# AGENDA

**June 21, 2012 Standards Committee Meeting**

REVISION TO INDIANA DESIGN MANUAL

REVISIONS TO VARIOUS SECTIONS OF THE INDIANA DESIGN MANUAL

Figure 409-2A

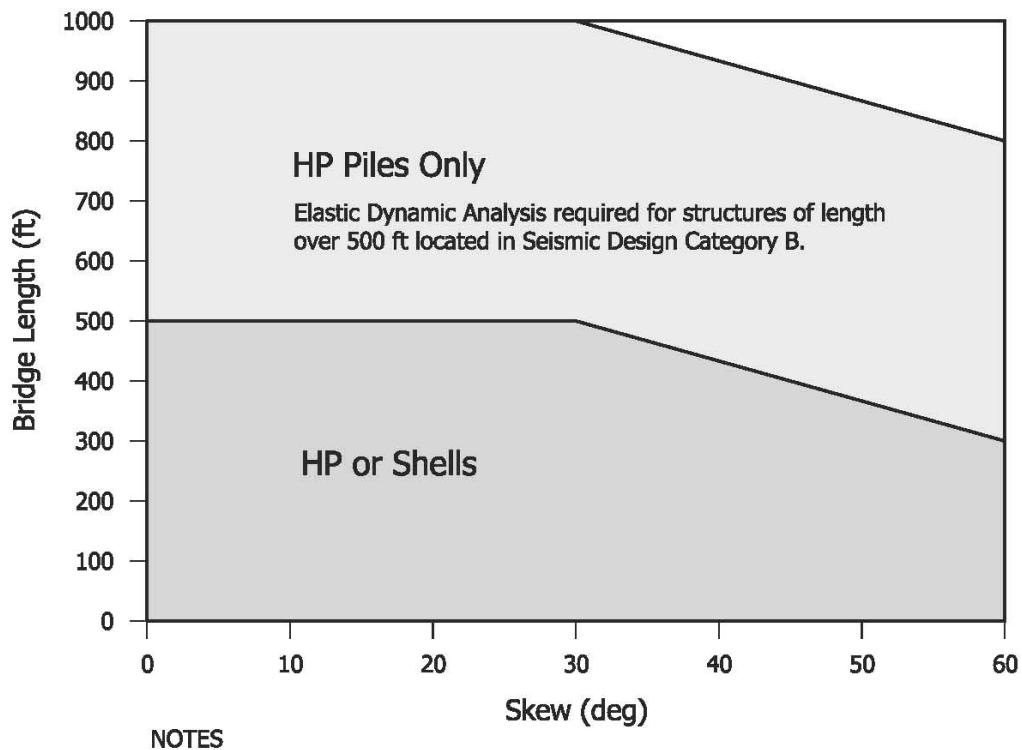
Figure 409-2A	Added new
Figure 409-2B	Added new
Figures 409-2C and -2D	Revised

Integral end bents should be used for a new structure in accordance with the geometric limitations provided in Figure 409-2A. Minimum support-length requirements need not to be investigated for an integral-end-bent bridge. Integral structures 500 feet in length or less will not require seismic analysis. Integral structures larger than 500 feet in length and located in a seismic design category B will be analyzed using elastic dynamic analysis.

~~For an existing bridge without integral end bents, the design criteria shown in Figure 409-2A should be used in evaluating the conversion to an integral end bent structure. For additional information, see Chapter 412.~~

1. Integral abutments may be used in a curved-alignment or curved-girder structure with length of 500 feet or less, with a subtended angle in plan not greater than 30°.
2. Pile confinement spiral reinforcement required on all integral abutments.

Figure 409-2B

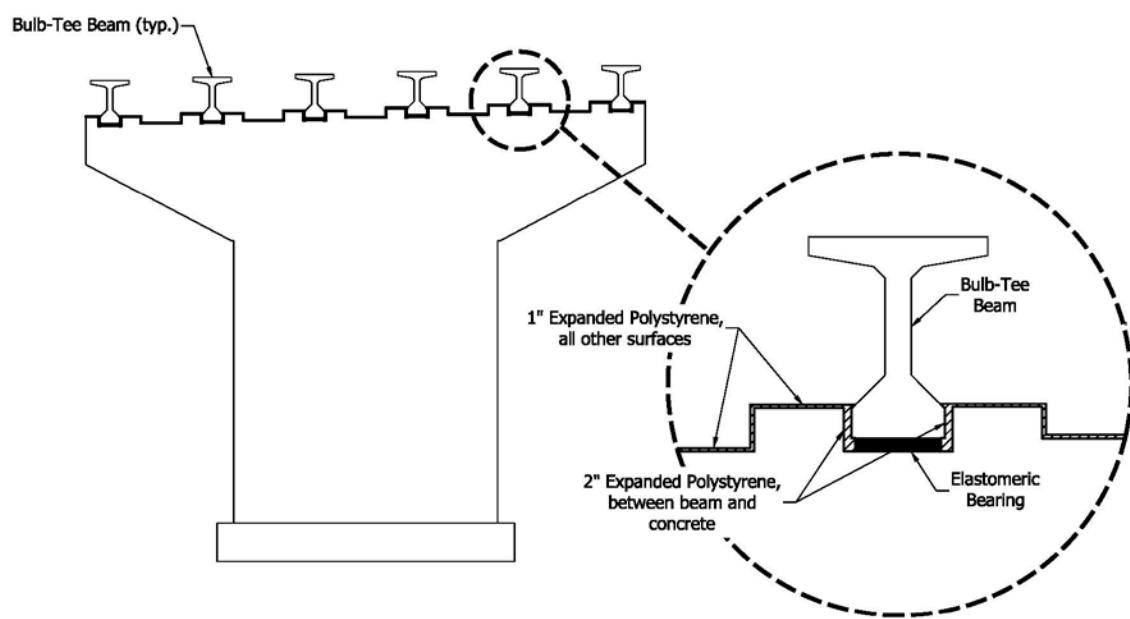
7. Intermediate Pier Details for Integral Structures Located in Seismic Areas Greater Than SDC A. Intermediate piers should include concrete restrainers as shown in figure 409-XX

Figure 409-2C  
(Page 1 of 4)

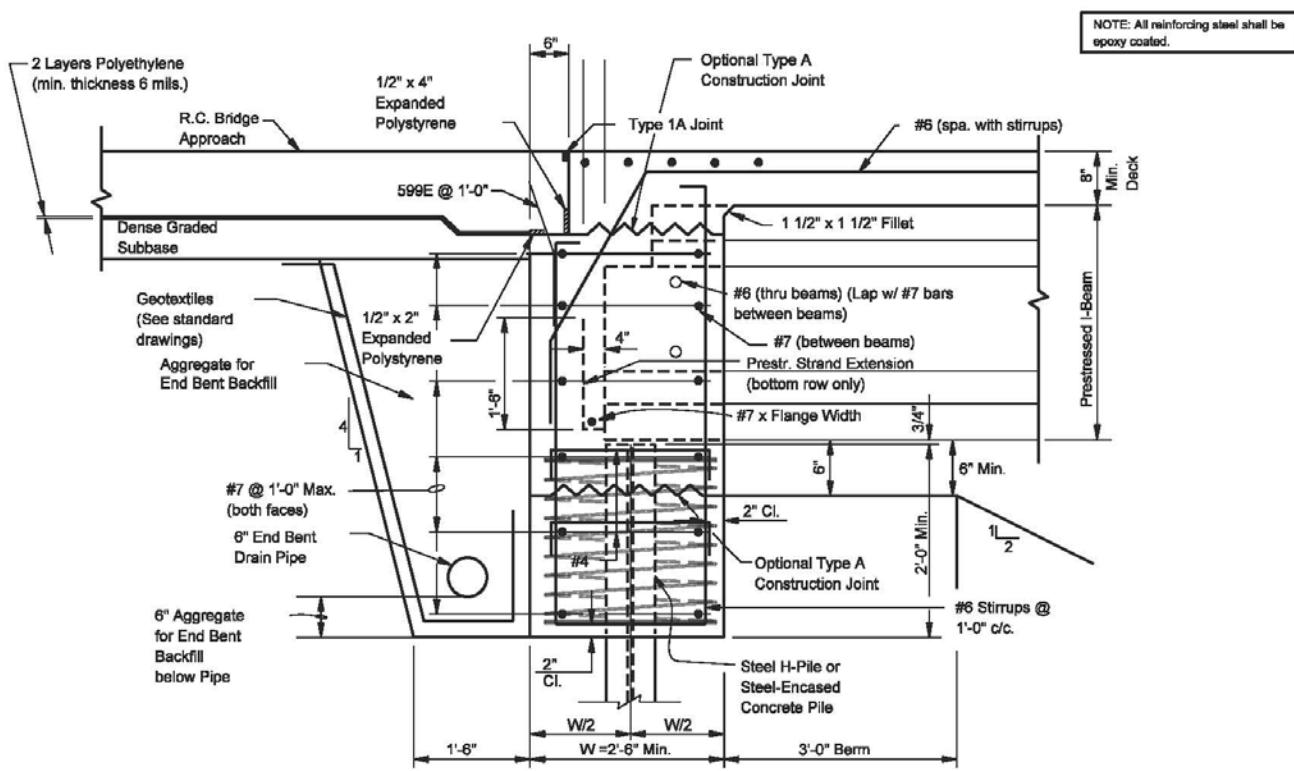
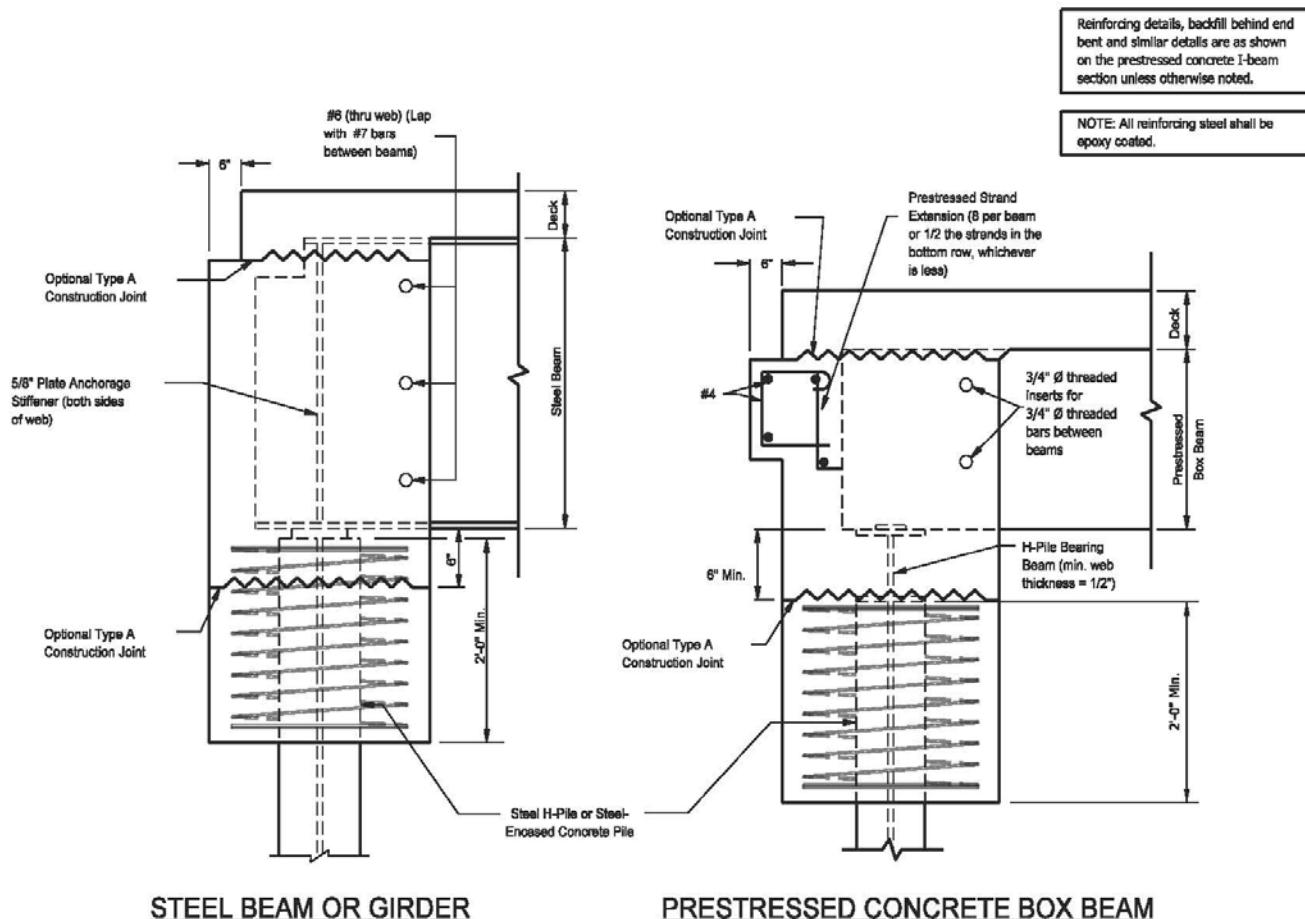
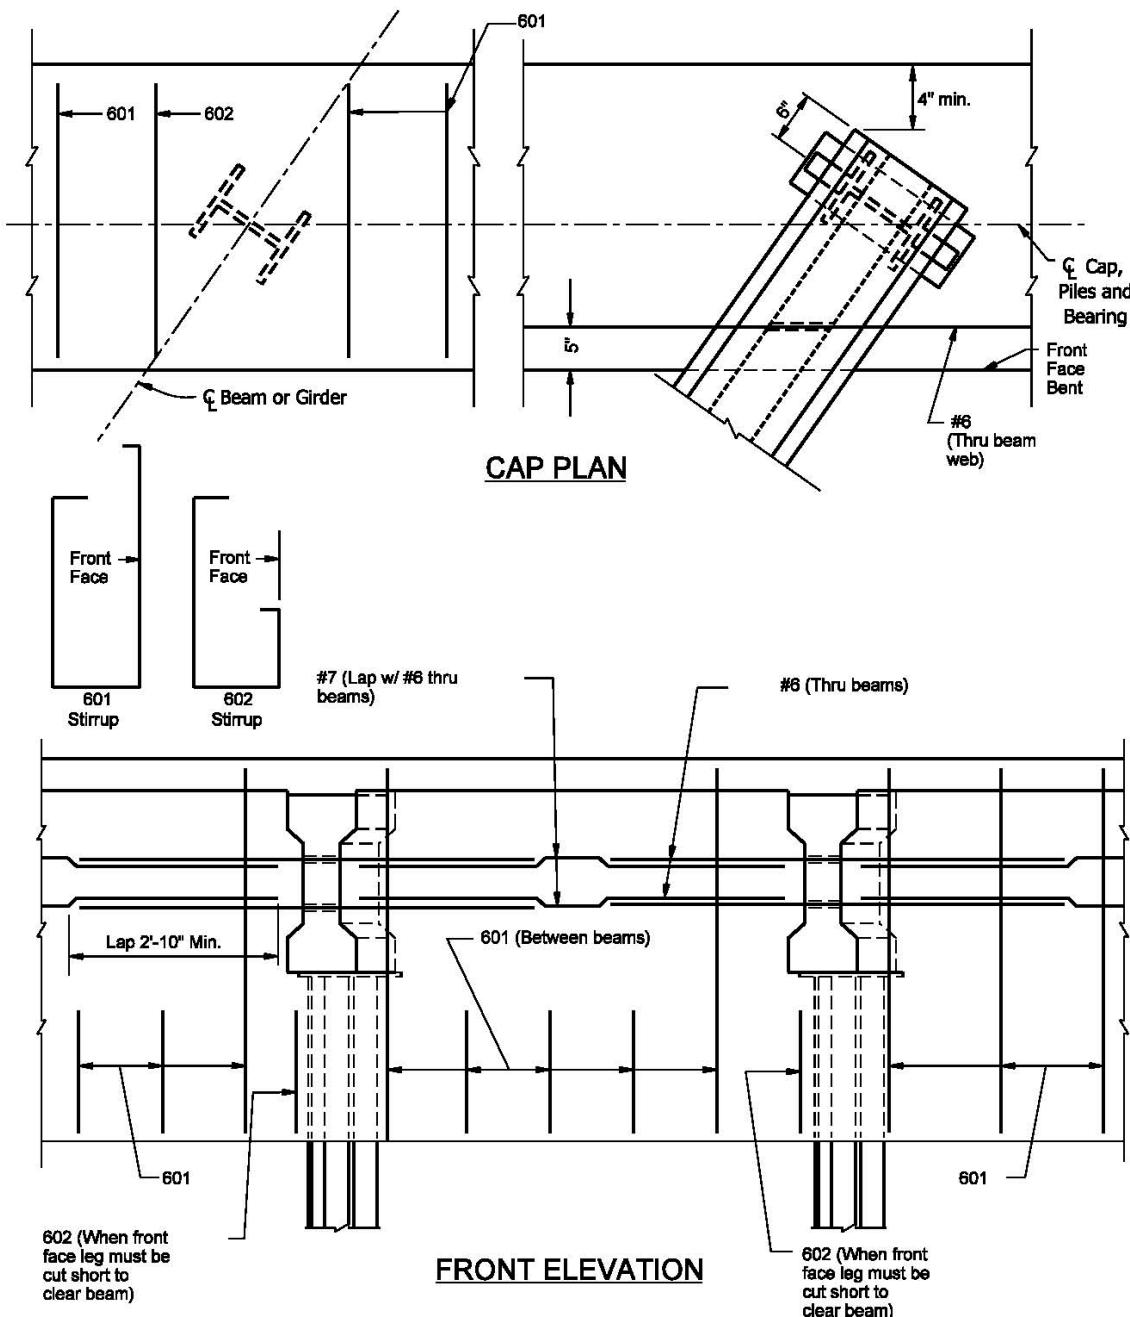
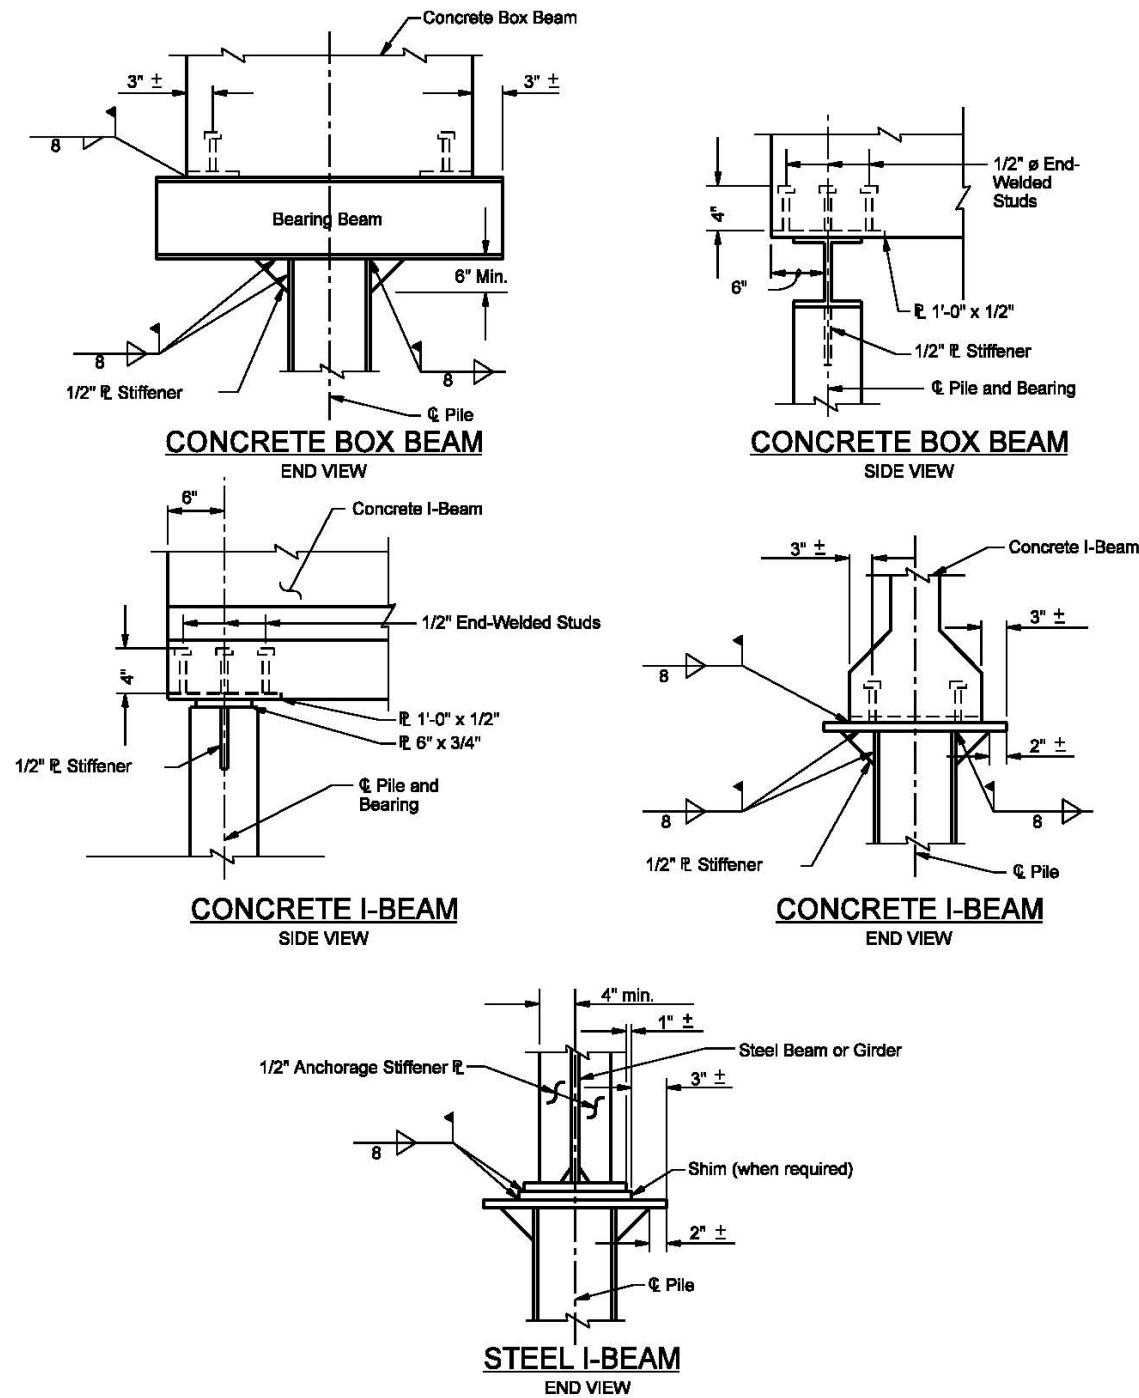
An integral end bent may be constructed using either of the methods as follows (See Figures 409-2B and 409-2C).
